Fuel Cells of the V-22 *Osprey* Joint  
Advanced Vertical Aircraft  
(D-2003-013)

Department of Defense  
Office of the Inspector General

Report No. D-2003-013

#### Naval Safety Center Data

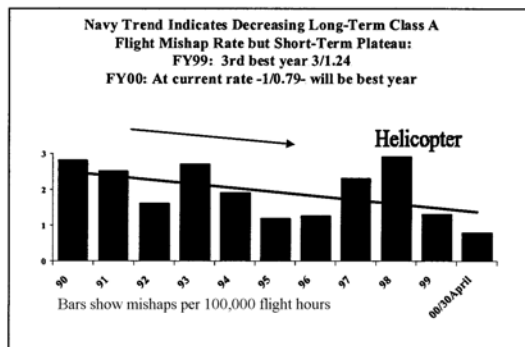
5. What was the source of the helicopter data used for the safety assessment, what was the population and population size the data was developed from, and what timeframe does the data represent? Did the data include helicopters without the capability to make an autorotation landing in the event of engine failure? Please provide a copy of the data used. (NOTE: We

**5. What was the source of the helicopter data used for the safety assessment, what was the population and population size the data was developed from, and what timeframe does the data represent? Did the data include helicopters without the capability to make an autorotation landing in the event of engine failure? Please provide a copy of the data used.**

\* Autorotations are performed in response to either total power loss (requires dual engine failures in all Navy/Marine Corp helicopters, including V-22) or due to tail rotor failures (for conventional helicopters). The vast majority of autorotations are due to tail rotor failures. Lack of tail-rotor will reduce the need for V-22 autorotation capability (compared to single rotor helicopters). The probability of having to conduct an autorotation is considered improbable. The data source for mishap rate is provided below:

**Navy Response.** The V-22 Program Office stated that autorotations are performed in response to total power loss, resulting from dual engine failures in Navy and Marine Corp helicopters, including the V-22; or in response to tail-rotor failures in conventional helicopters for which the vast majority of autorotations occur. Because the V-22 does not have a tail rotor, the need for autorotation capability is reduced. For its mishap rate, the V-22 Program Office provided a graph, "Naval Safety Center Data," as the data source. In addition, the Program Office listed four data sources to support the "Naval Safety Center Data" assessment.

**Audit Response.** The Navy did not provide the population and population size for the "Naval Safety Center Data" and copies of support data. Further, the times given in the data sources were unclear about whether they were timeframes of data or publication dates of studies.

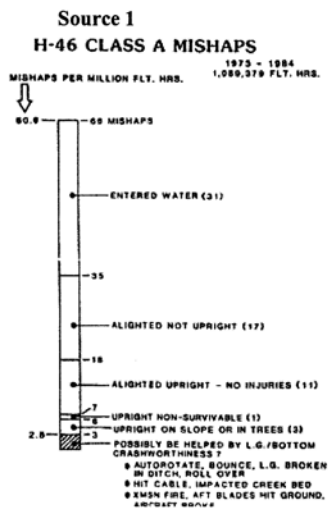
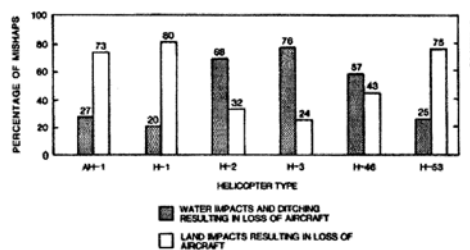
7. What was the source for the data that was used to develop the "probability that a crash occurs over land" factor, what was the population and population size the data was developed from, and what timeframe does the data represent? Please provide a copy of the data used.

**7. What was the source for the data that was used to develop the “probability that a crash occurs over land” factor, what was the population and population size the data was developed from, and what timeframe does the data represent? Please provide a copy of the data used.**

The V-22 is a replacement for the H-46. The data below fully supports the 50% over land statement.

H-46 Data: Source 1 data source shows 31/66 = 47% water crashes, Source 2 data 57% water crashes, Source 4 data shows 32/52 or 62% water crashes.

**Navy Response.** The V-22 Program Office stated that the V-22 is a replacement for the H-46 helicopter and provided 4 sources for data to support the “probability that a crash occurs over land” factor of 50 percent. The 4 sources showed the probabilities of water crashes as 47 percent, 57 percent, 55 percent, and 62 percent, respectively.

**Audit Response.** The source 1 and 2 data were old, 1973 through 1984 and 1972 through 1981, respectively; and the source 3 data were unclear as to whether 55 percent of the helicopter mishaps occurred over water. Further, the source 4 data were not for EMD aircraft and generally supported the “probability of crash over land” factor equating to 50 percent.

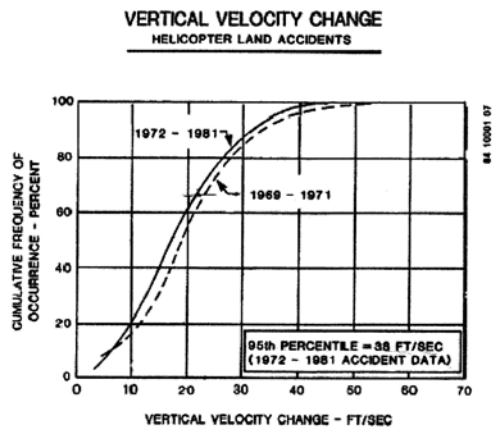
8. Please provide evidence that the factors "probability that a crash is survivable" and "probability that a crash occurs over land" are actually mathematically independent factors.

**8. Please provide evidence that the factors “probability that a crash is survivable” and “probability that a crash occurs over land” are actually mathematically independent factors.**

Source 4 data indicates that:

32 of the 157 water mishaps (or 20% of water mishaps were considered non-survivable).  
44 out of 127 land mishaps (or 35% of land mishaps were considered non-survivable).

**Navy Response.** The V-22 Program office stated that data is not currently available to show that the “probability that a crash is survivable” and the “probability that a crash occurs over land” are totally independent. Further, the Program Office stated that some degree of statistical dependence may exist; however, that degree is unknown. In the V-22 mishaps, three were land crashes and one was survivable. The V-22 Program Office also stated that fuel cell crashworthiness would not have been a factor in 75 percent (3 out of 4) of the mishaps because impact loads far exceeded the survivable mishap threshold for humans. Further, the Program Office stated that source data indicates that 20 percent (32 divided by 157) of water mishaps and 35 percent (44 divided by 127) of land mishaps were considered nonsurvivable.
